SUBMITTAL IDENTIFICATION SHEET

WEBSTER UNIVERSITY ISB
PROJECT NAME

079200-006
CONTRACTOR / CM SUBMITTAL NO.

Photo documentation of how fasteners were installed for the mockup.

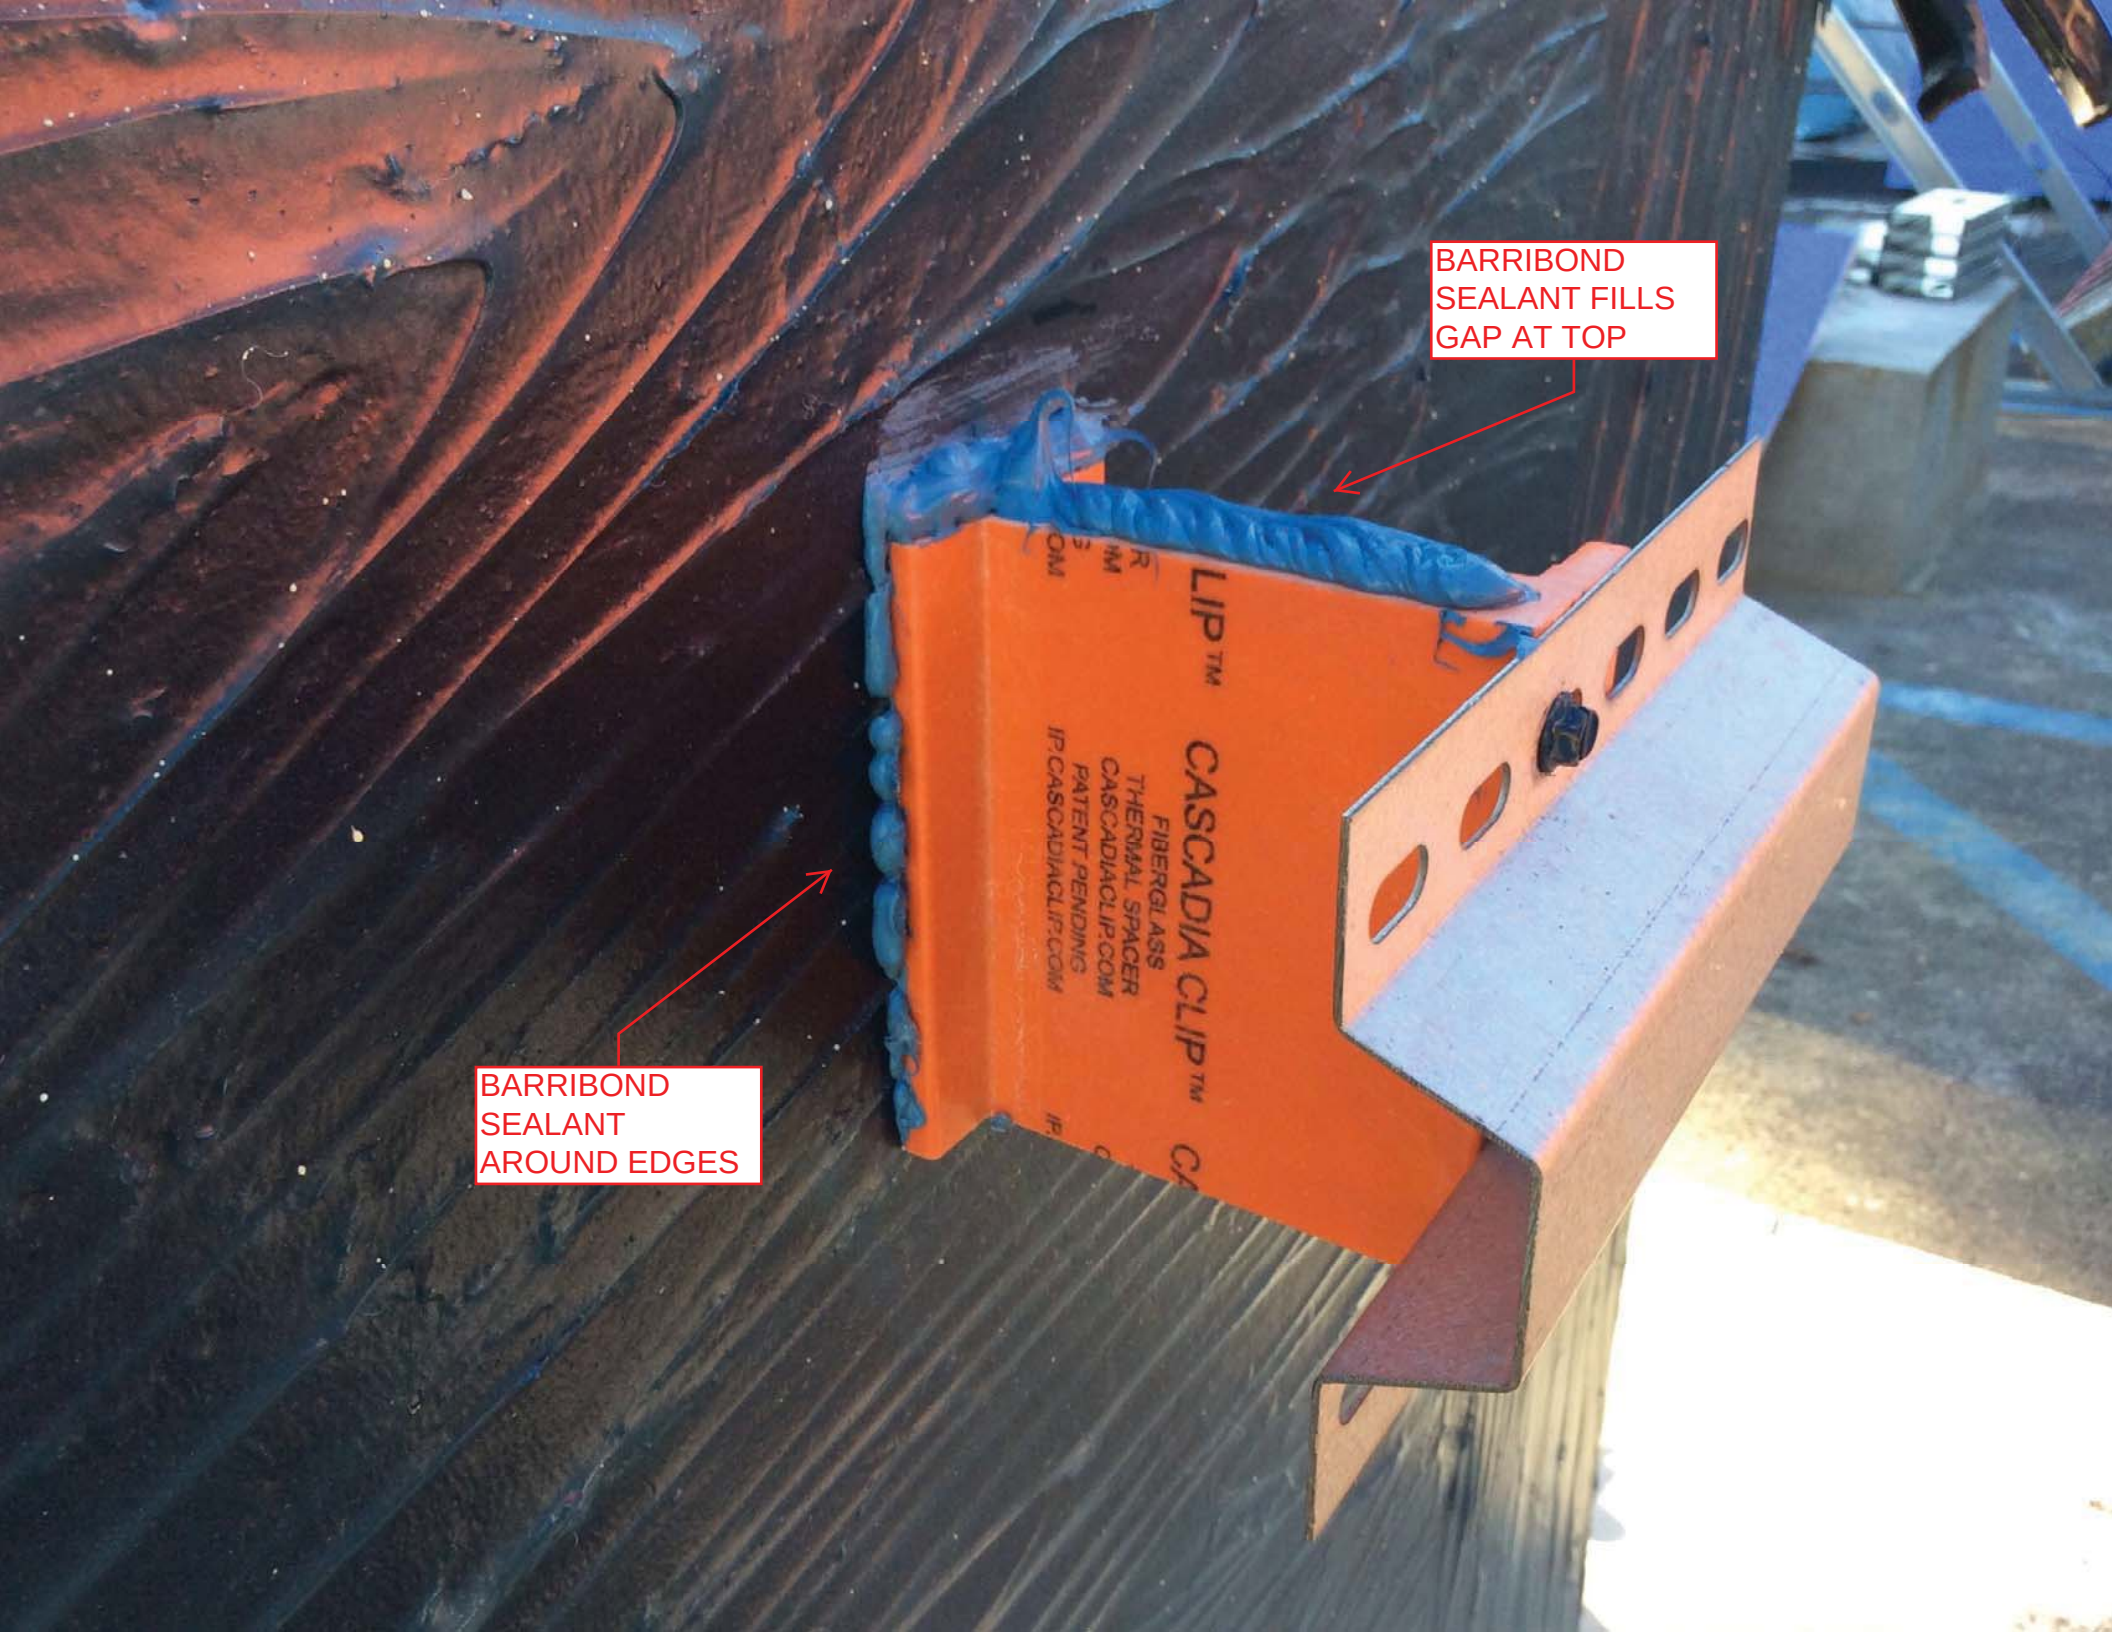
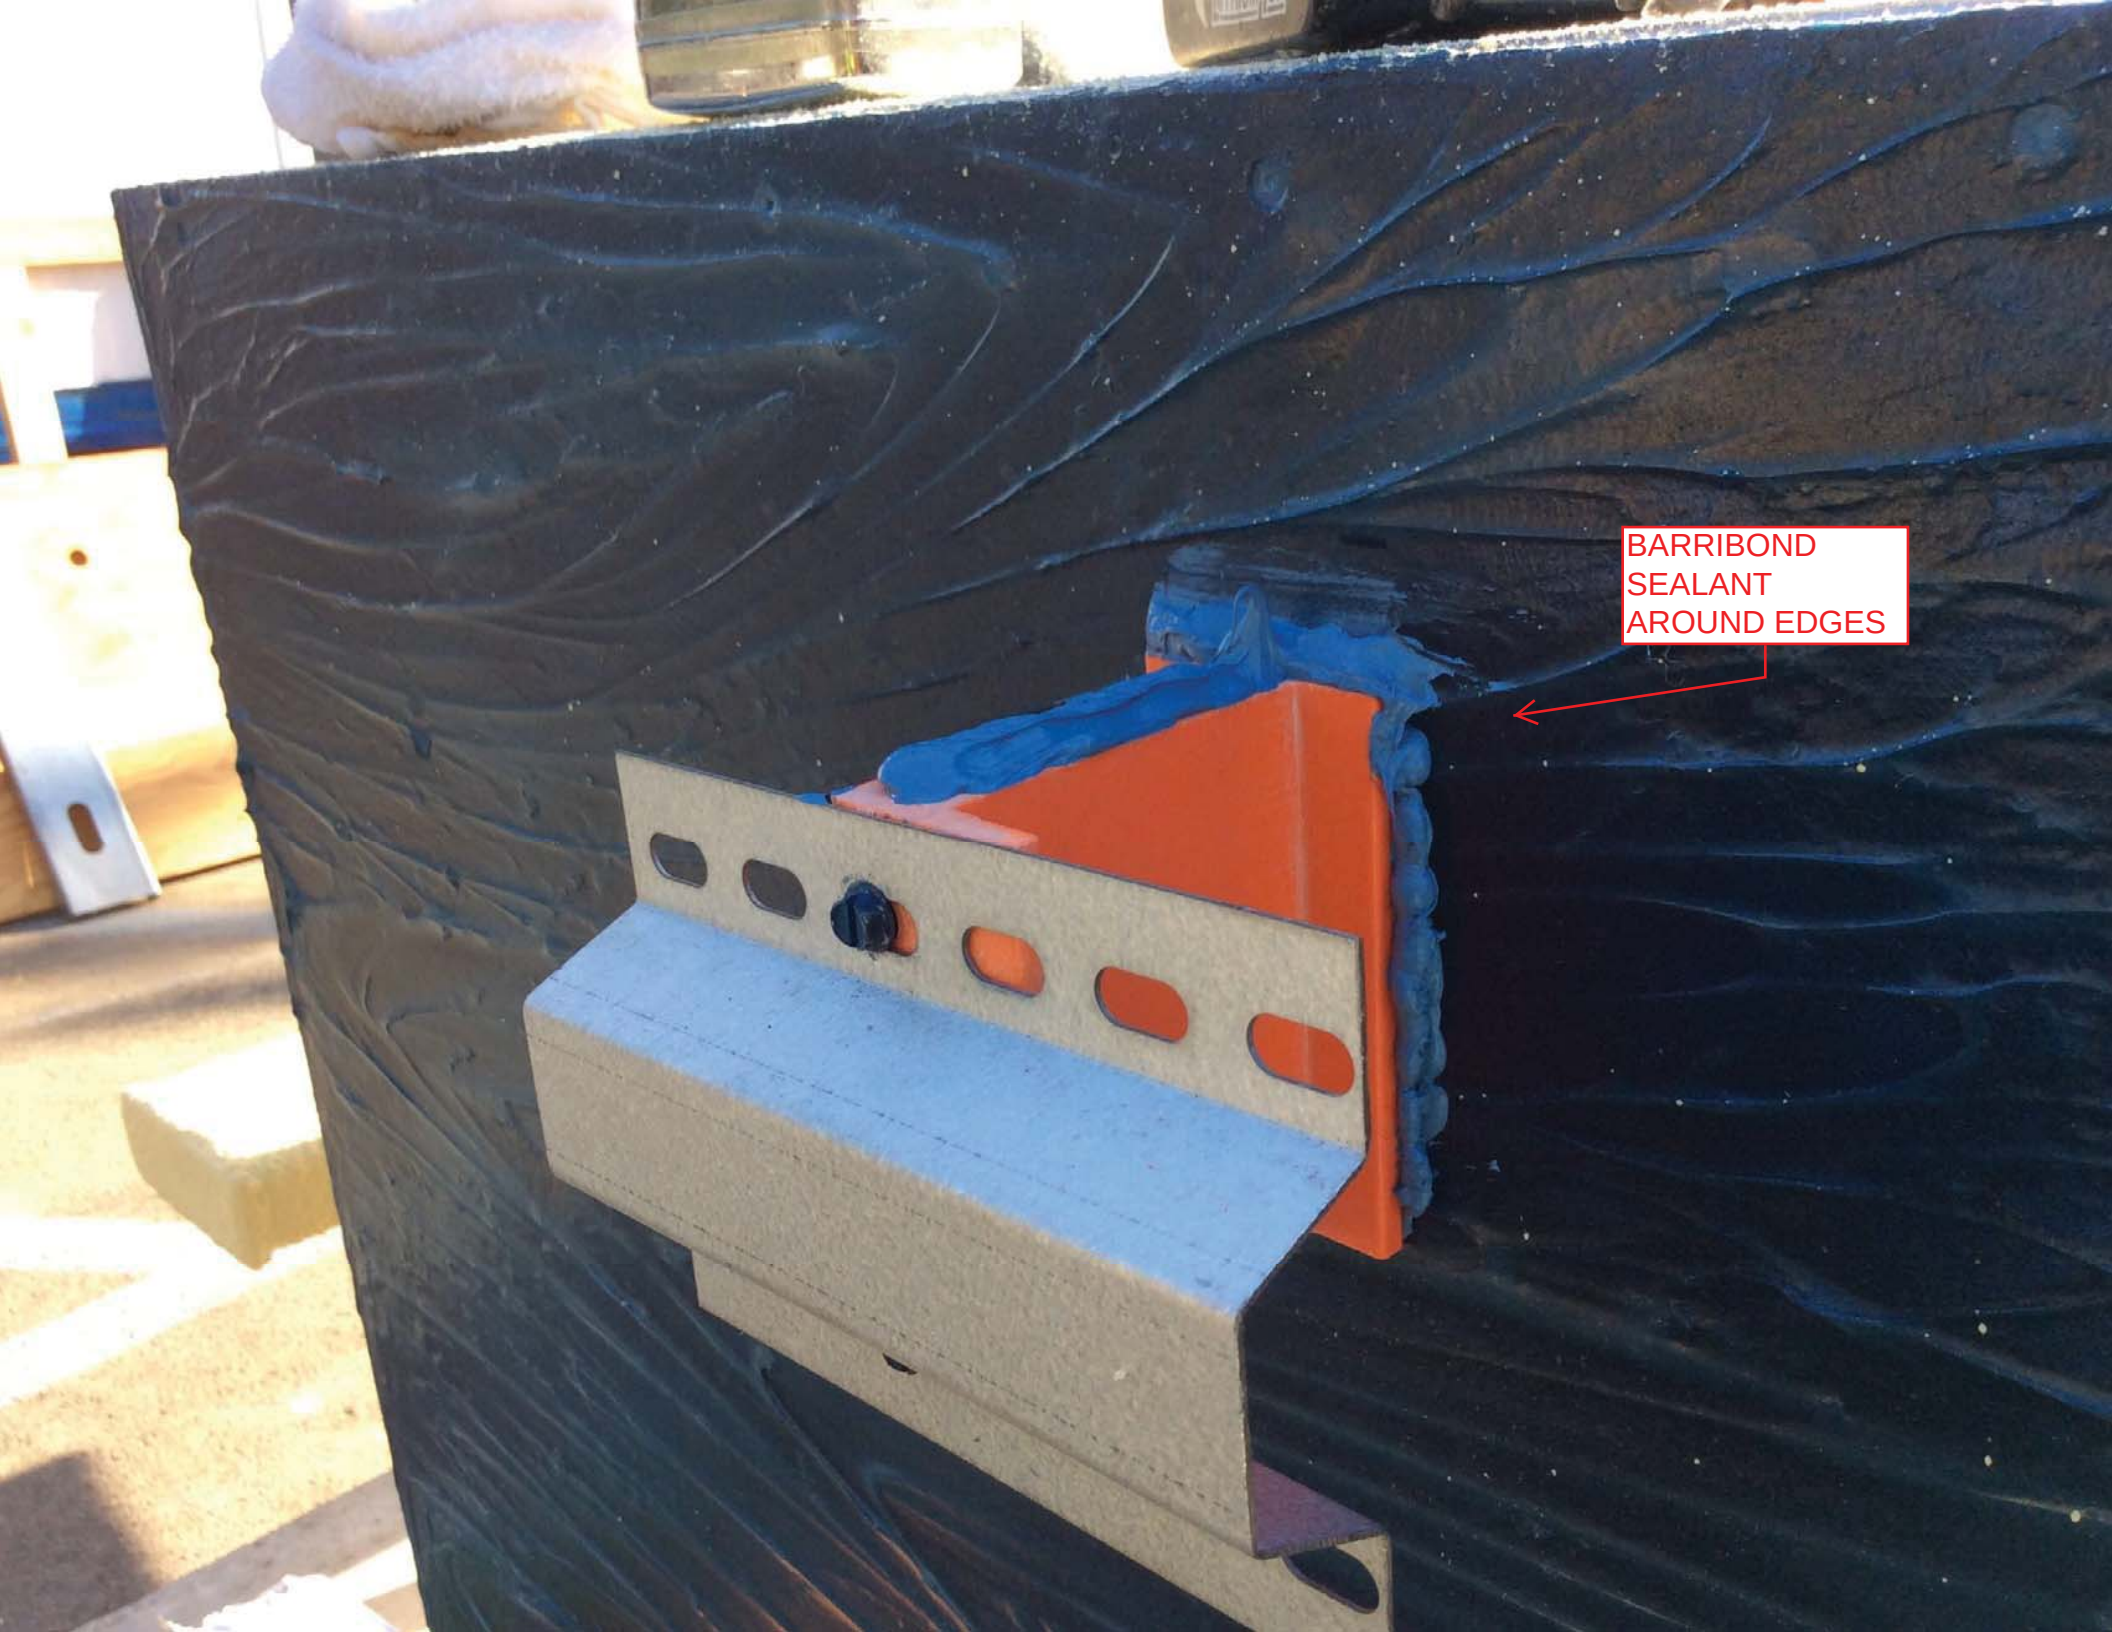
Contractor shall ensure perimeter sealant is secured continuously to both the edge of the clip and the AVB, no holes or gaps will be allowed.
